**SERVICE
BULLETIN**

mazda

RX-7 (13B)

SUBJECT Filter for the Vent Solenoid Valve.

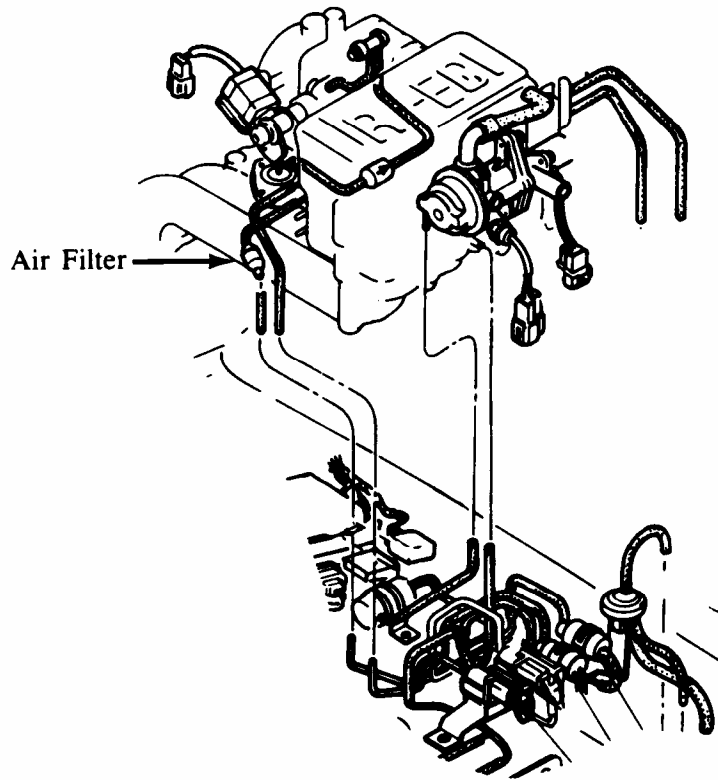
To prevent high idle speed or idle speed hunting caused by a sticking vent solenoid valve, an air filter has been installed between the dynamic chamber and vent solenoid valve since the production date of March, 1985.

Whistle Noise from Check & Cut Valve.

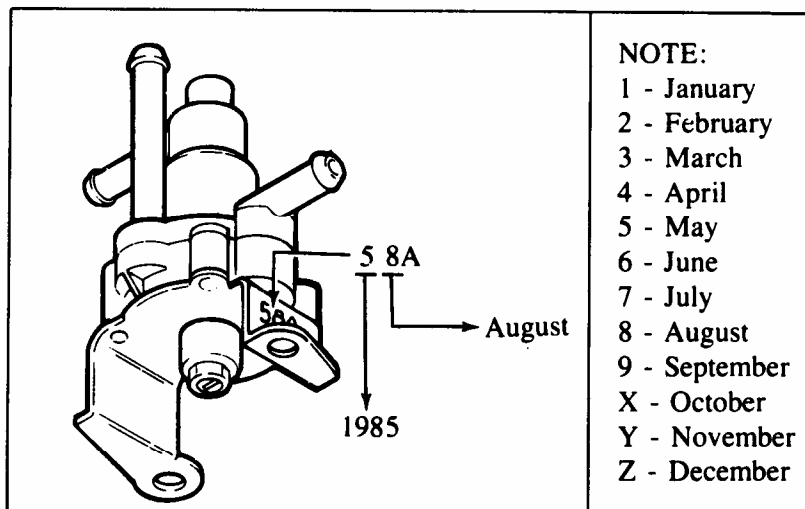
Modified check & cut valves are available as service parts for 1981-1985 RX-7 and 1982-1985 GLC in order to prevent a whistle noise. The whistle noise tends to occur from the check & cut valve at high temperature and low fuel level, and can be heard from the rear of the vehicle.

The part numbers of 8341-42-910 for RX-7/GLC and BA01-42-910 for GLC have not been changed, however, a modified check & cut valve can be distinguished from an unmodified one by the production date stamped on the bracket as shown.

The check & cut valves produced on and after the following date are the modified ones.

RX-7 August 10, 1985 (58A)
GLC September 1, 1984 (49A)

SUBJECT Counter Shaft Gear & Lock Nut.

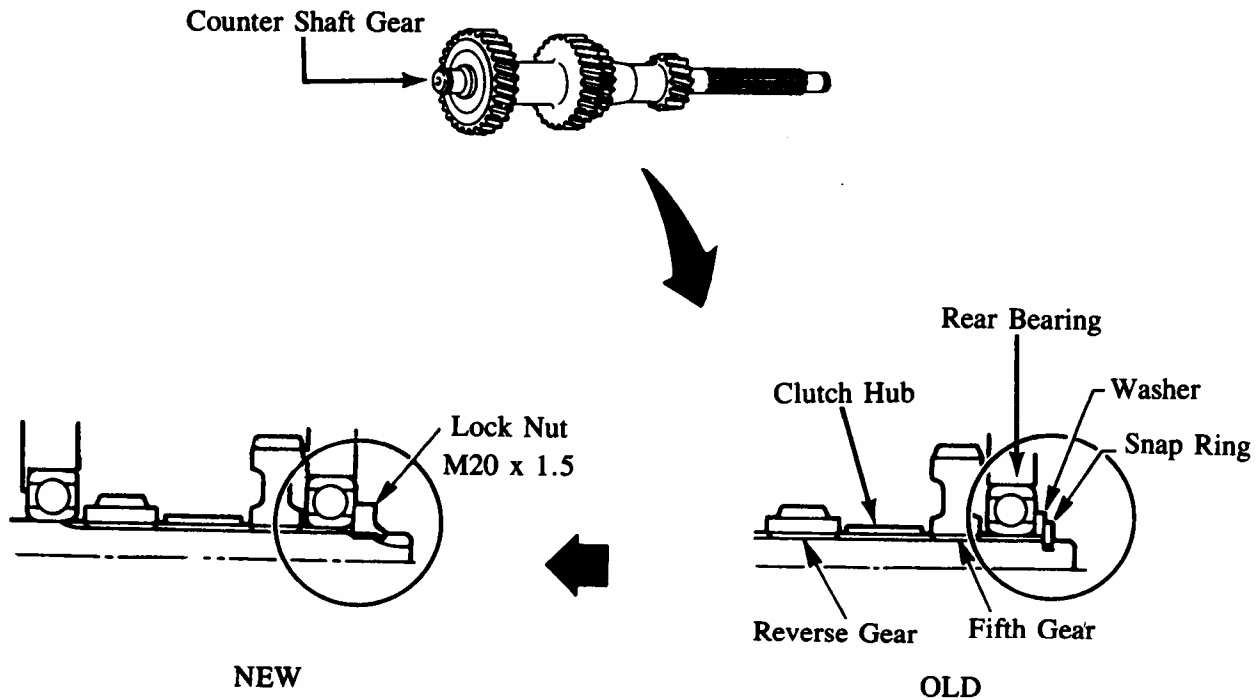
In order to retain the rear bearing on the counter shaft gear more securely, the snap ring has been replaced by a lock nut.

- Tighten the lock nut to: 94-145 ft-lb
127-196 N-m
13-20 kg-m

- Stake the lock nut as shown:

SUBJECT Roller Bearing & Main Shaft.

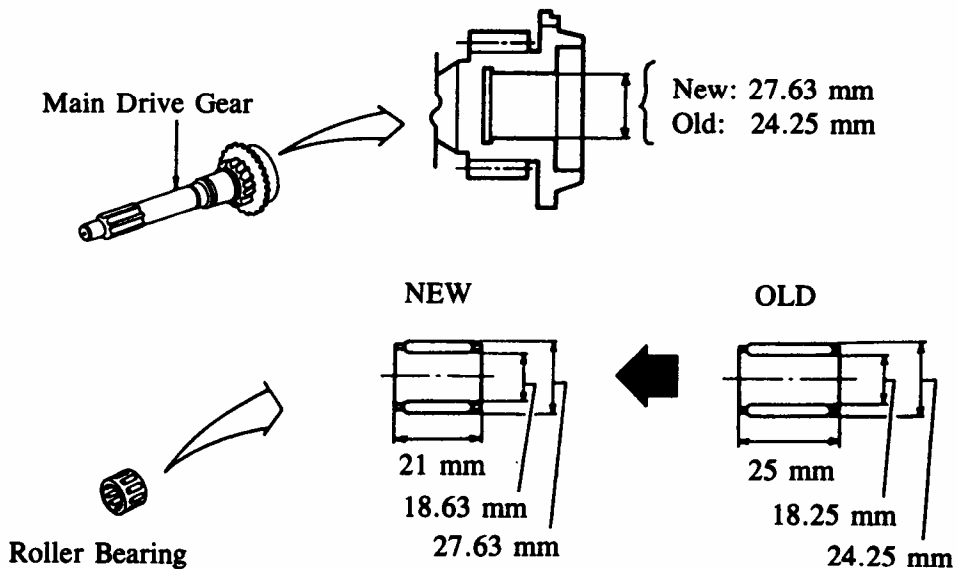
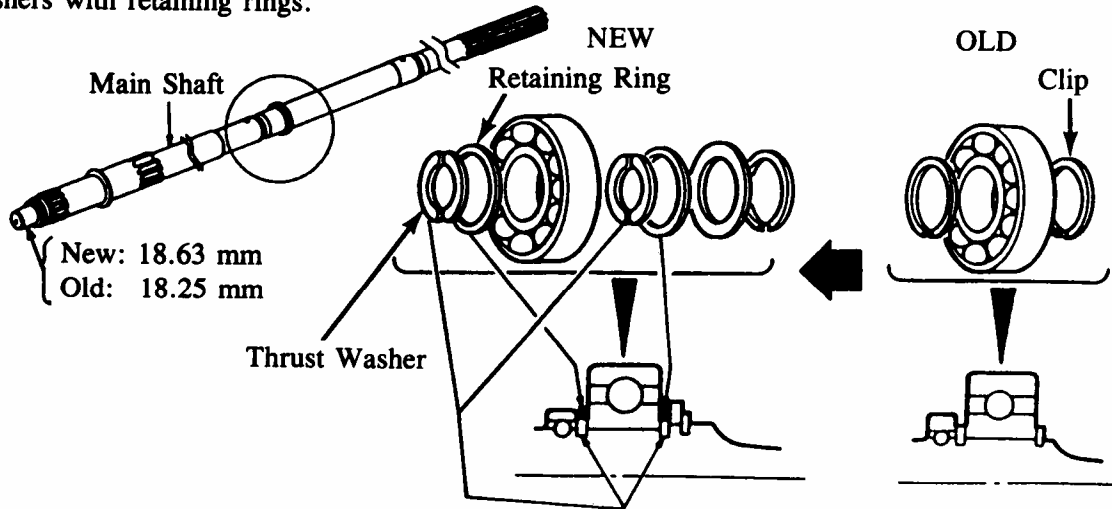
1. The roller bearing has been enlarged and the recess in the main drive gear has been enlarged to accept the new roller bearing.

2. The method of retaining the bearing on the main shaft has been changed from clips to thrust washers with retaining rings.

SUBJECT Transmission Front Bearing Modification.

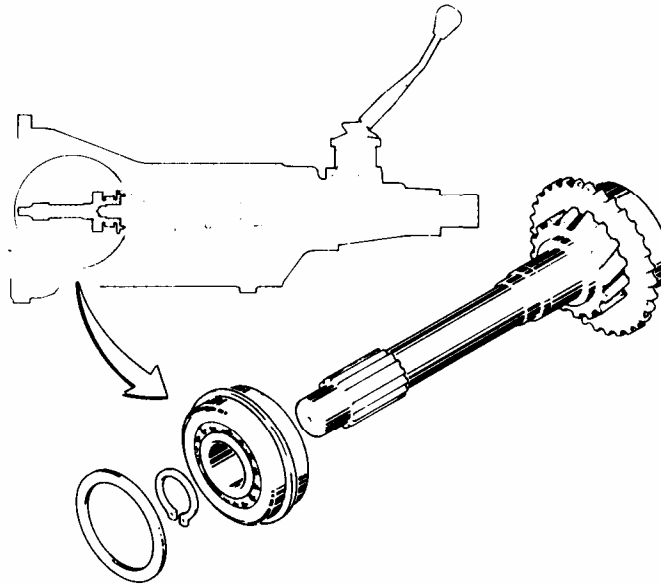
The ball bearing of the main drive gear has been changed to a specially heat treated bearing in order to further improve the durability of the transmission.

SUBJECT Wiper Link.

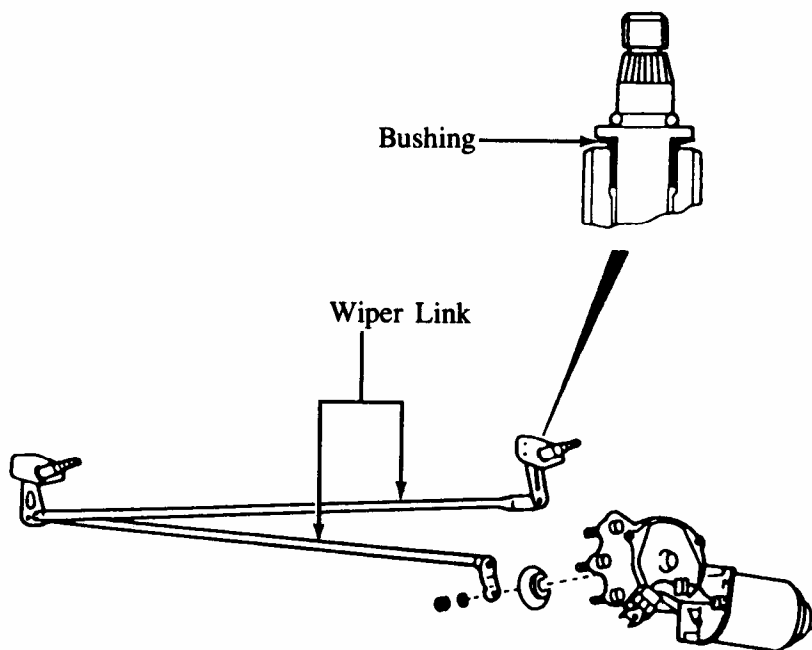
A new wiper link has been established as a service part. This new wiper link features a bushing as shown below.

A new part can be used in place of the former part, but the former part may not be used in place of the new part.

SUBJECT Engine Harness.

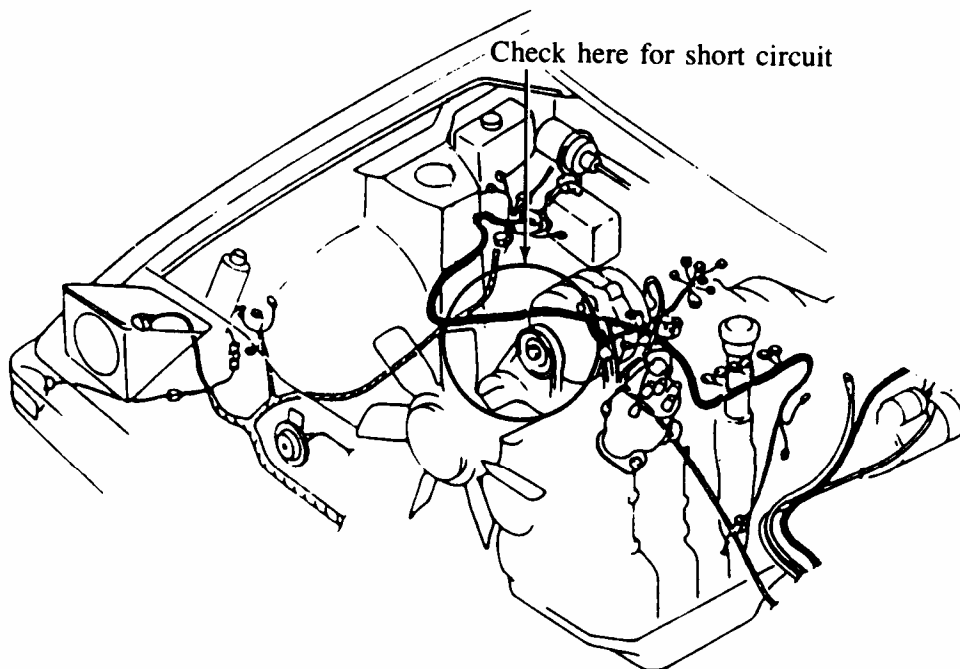
If the "ENGINE" fuse blows, preventing the engine from starting, the problem may be due to an electrical short circuit in the engine harness. Carefully inspect and repair the engine harness, if necessary, in the area of the thermostat and air hose to the air cleaner.

To prevent short circuiting, the clearance between the engine harness and the air hose to the air cleaner has been increased since the production of October 1, 1984.

SUBJECT Rear Harness.

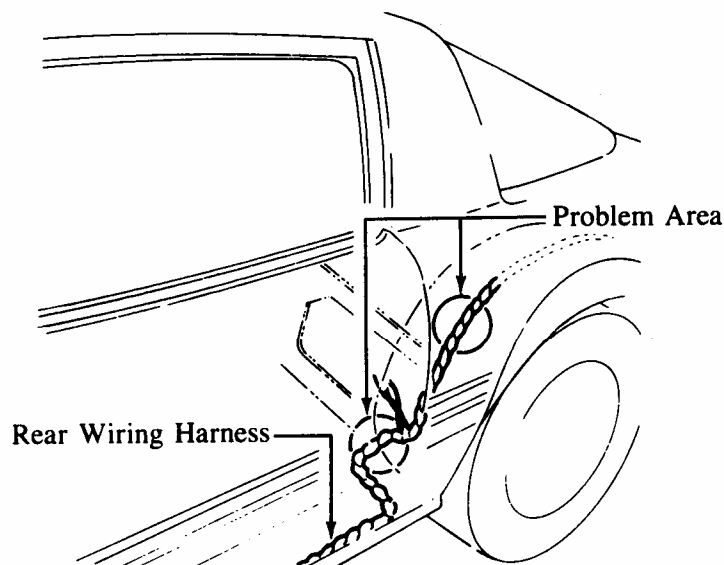
Many electrical problems and blown fuses may be caused by a short circuit in the rear harness. The rear harness may be cut by a sharp metal edge where the harness is routed over the inner wheel well. Some electrical problems reported from the field include:

To prevent this problem, the routing of the rear harness has been changed since the production of July 11, 1984.

If this problem is found, repair the rear harness as necessary and wrap the harness with foam rubber to protect the harness from contact with the sharp metal edges in the area shown.

A. Figure 47U09X-031 (Addition to illustration)

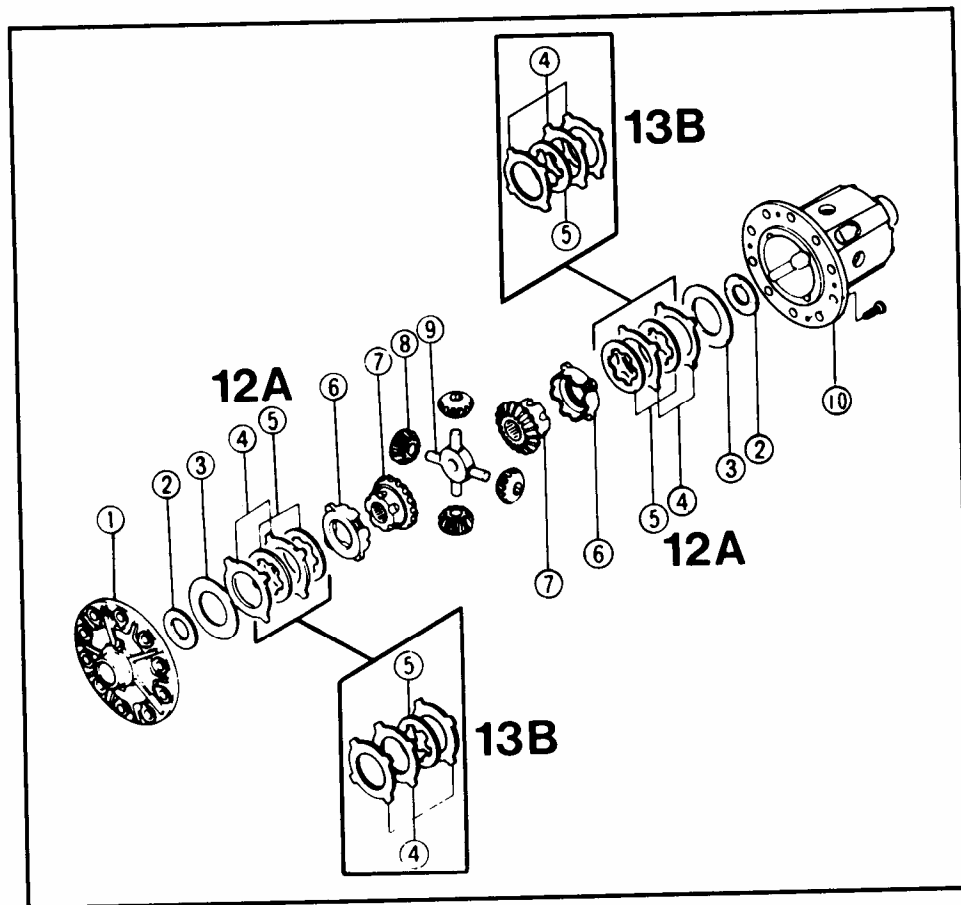
NOTE: The quantity and installation order of friction discs and plates are corrected below.

- 1) Differential case left
- 2) Thrust washer
- 3) Conical spring
- 4) Friction plate
- 5) Friction disc
- 6) Pressure ring
- 7) Side gear
- 8) Pinion gear
- 9) Spider
- 10) Differential case right

B. Figures 47U09X-054, 055 and 056 (Replacement for Assembly of differential - LSD model)

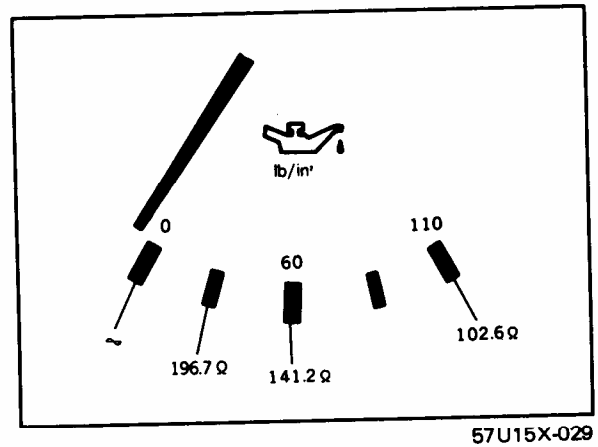
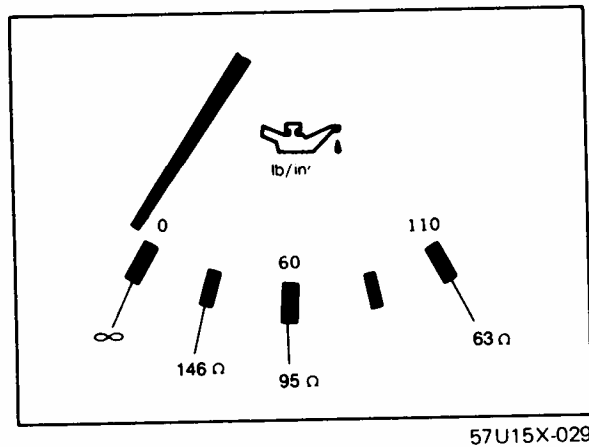
NOTE: The quantity and installation order of friction disc and plate are corrected below.

Order	Engine	12A	13B
1		Thrust washer	
2		Conical spring	
3		Friction plate	Friction plate
4		Friction disc	Friction plate
5		Friction plate	Friction disc
6		Friction disc	Friction plate
7		Pressure ring

Order	Engine	12A	13B
8		Side gear	
9		Pinion gear and spider assembly	
10		Side gear	
11		Pressure ring	
12		Friction disc	Friction plate
13		Friction plate	Friction disc
14		Friction disc	Friction plate
15		Friction plate	Friction plate
16		Conical spring	
17		Thrust washer	
18		Differential case left
